Alternative SHOCK for Armor

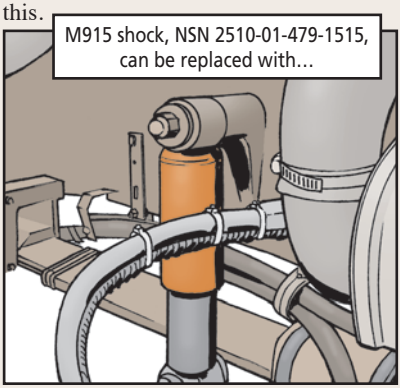
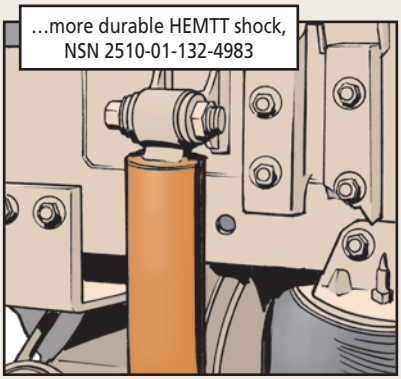
If your unit has up-armored M915A3 trucks, you may have already noticed that the front shocks, NSN 2510-01-479-1515, don't handle the added weight of the armor too well.

Some Soldiers have found busted shocks, leaking fluid and worn tires that need replacing too soon! But you can stop this.

One unit at Ft Campbell discovered that installing HEMTT shocks, NSN 2510-01-132-4983, fixed this problem. This NSN brings the upper and lower bushings and the shock. It fits right on, too, so no mods are needed. Plus, TACOM LCMC approves this.
